451 Smyth Road Ottawa, ON K1H 8M5

Urban Design Brief

Issued 4/18/2024

Prepared by Parkin Architects Limited

Landscape plan outlining green space and tree/shrub locations within area of work

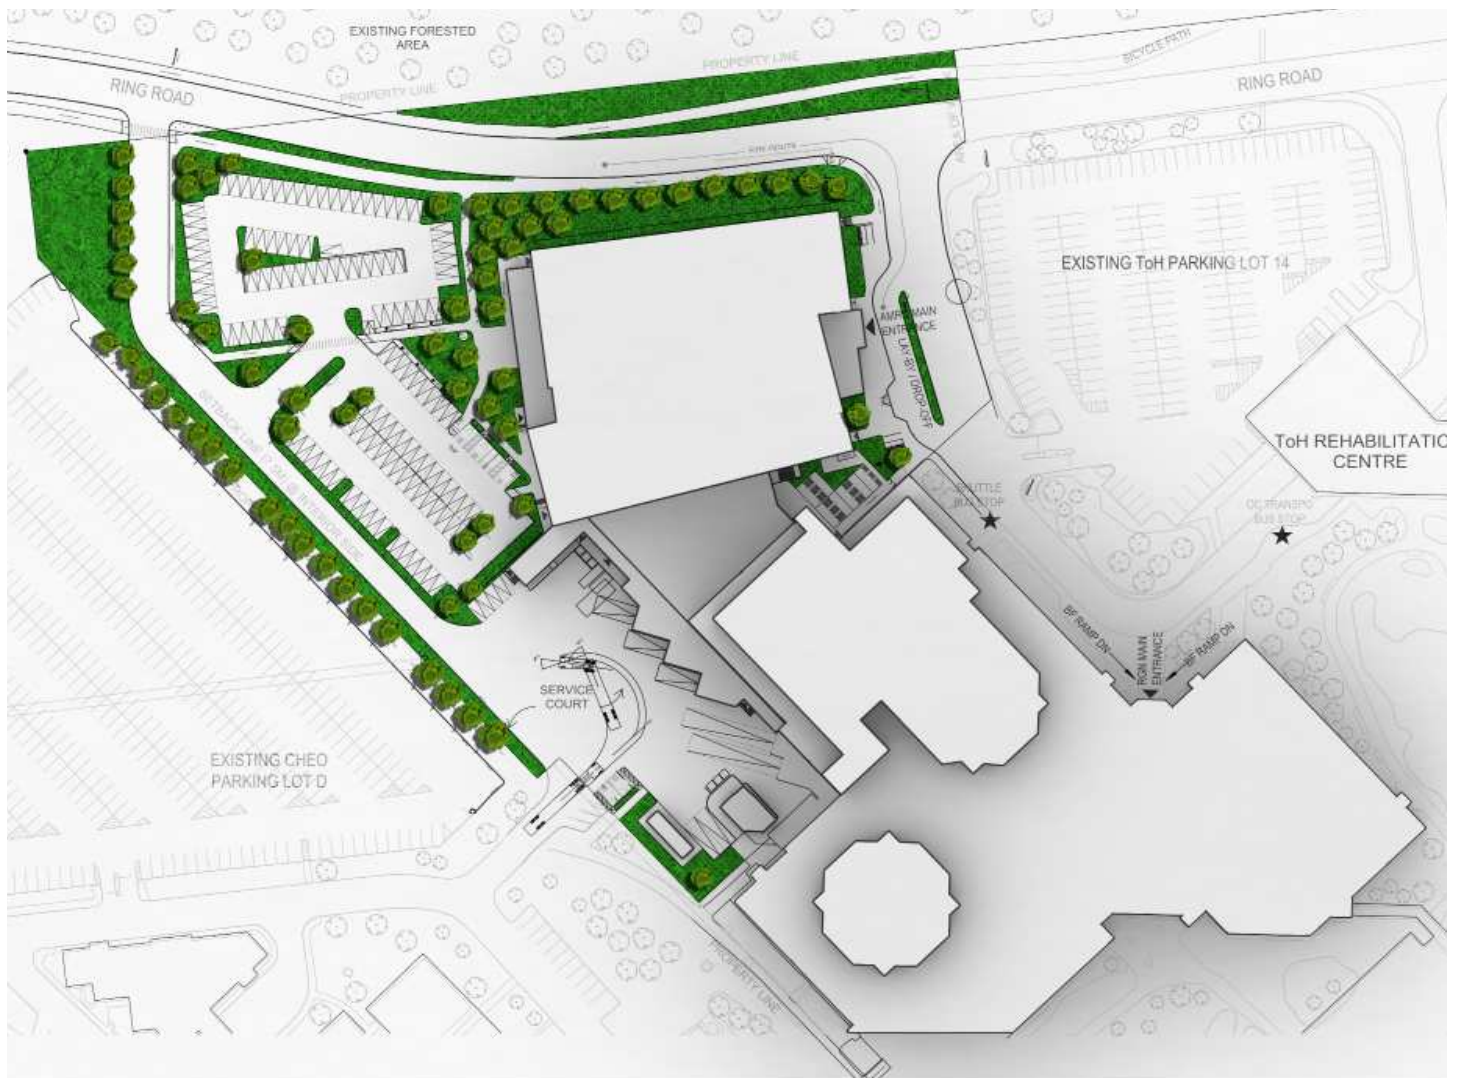
13) Staff encourage the applicant to retain and enhance as much of the landscaping along Ring Road as possible.

While the retention of existing trees on site will not be possible due to the extensive work that will take place, the reintroduction of landscaping is absolutely a priority.

Service Access

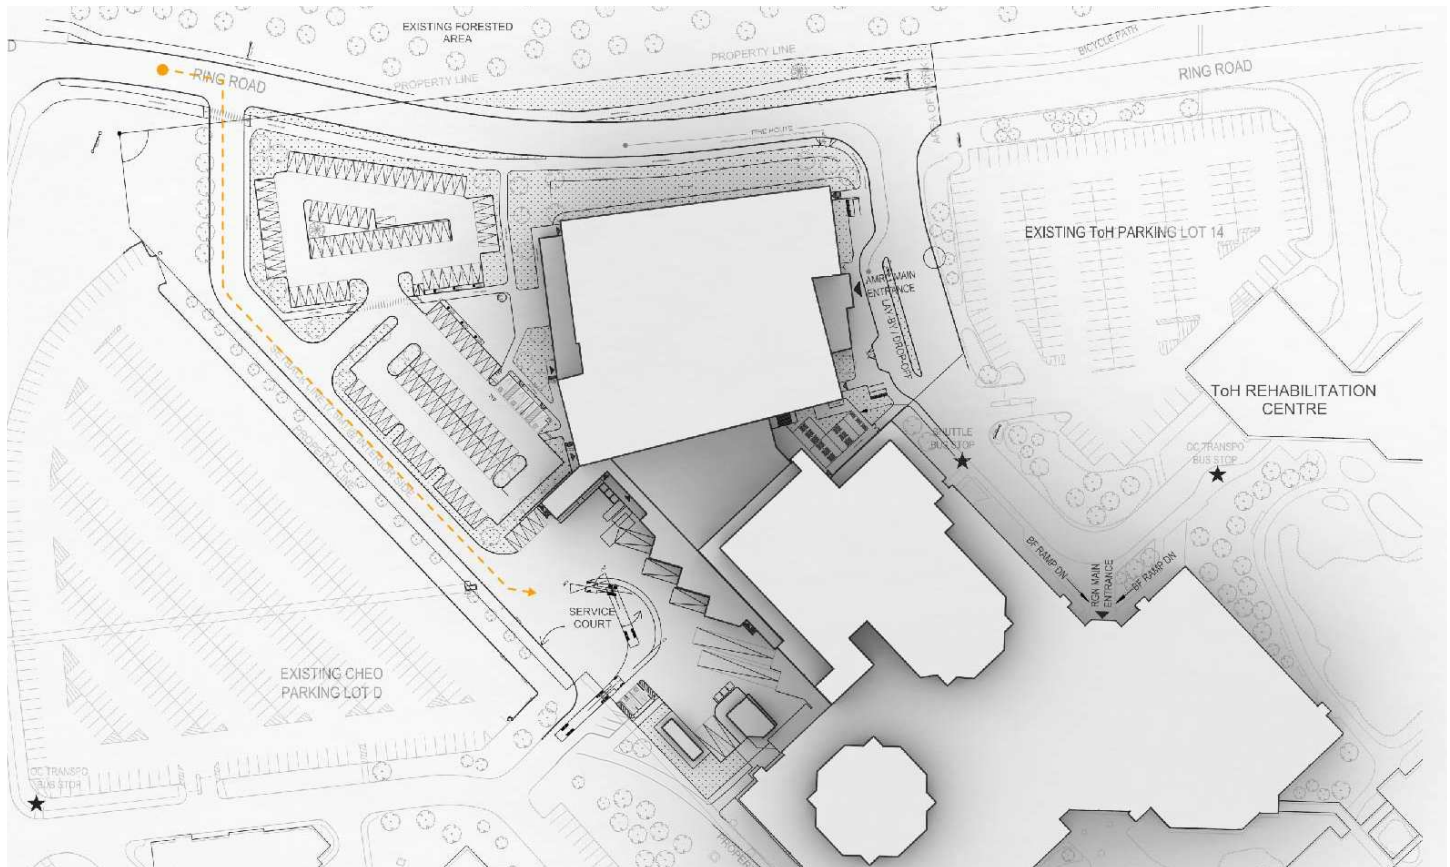
12) Staff appreciate the consolidation of pick-up and drop off for the building and the location of loading. Staff would like to see the loading area screened from Ring Road as much as possible.

The loading area will be concealed by the hazardous waste facility and the use of screens and landscaping.

Vehicular Parking - Area of Work

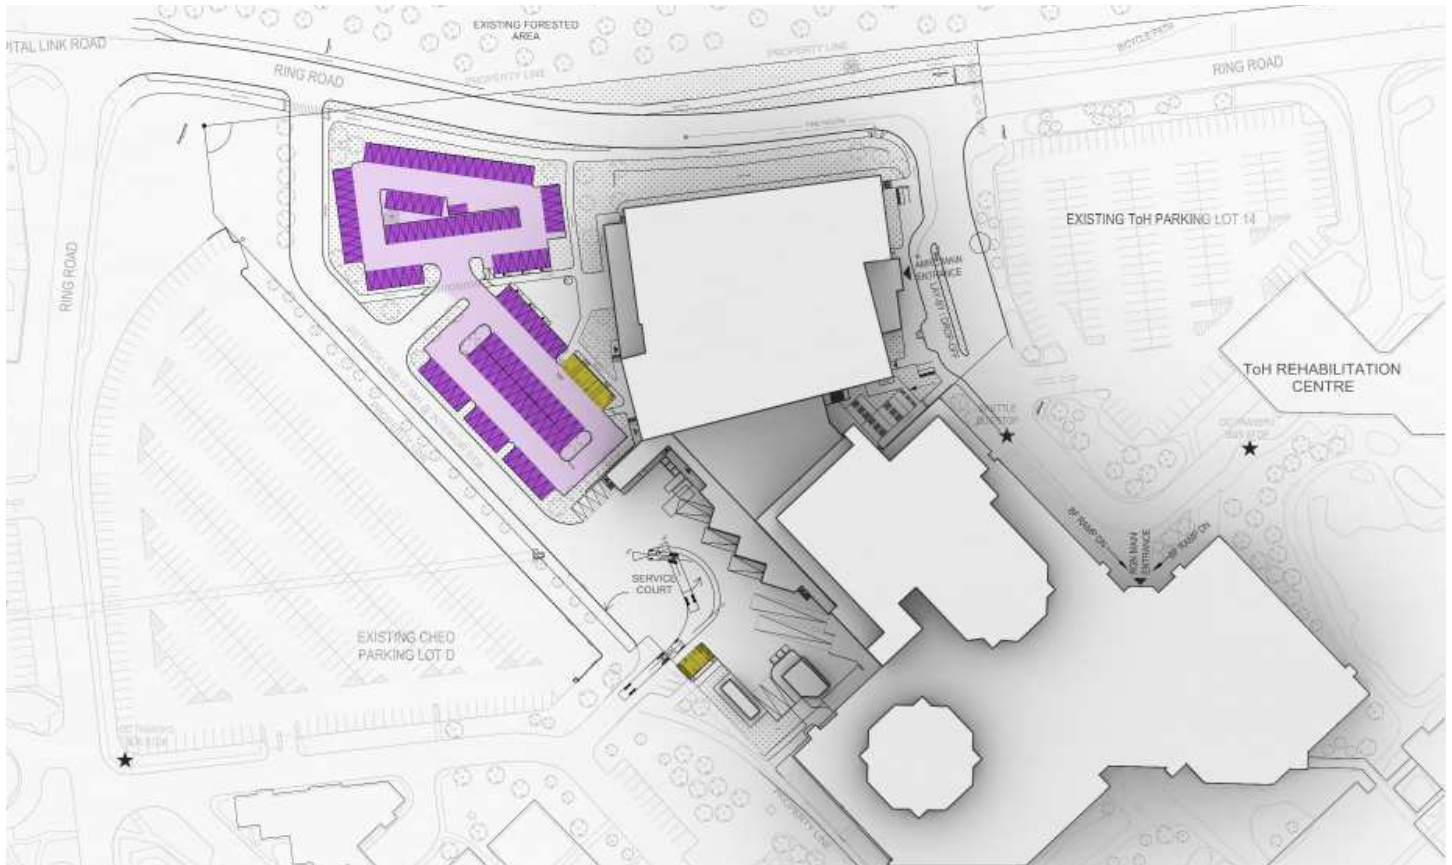
11) For any surface parking areas, staff encourage the applicant to consider permeable surfaces and planting along the perimeter and throughout the parking areas. Clear pedestrian connections are also needed.

Planting along the perimeter and in parking areas has been implemented, and permeable pavement will be considered and reviewed with the design team and client.
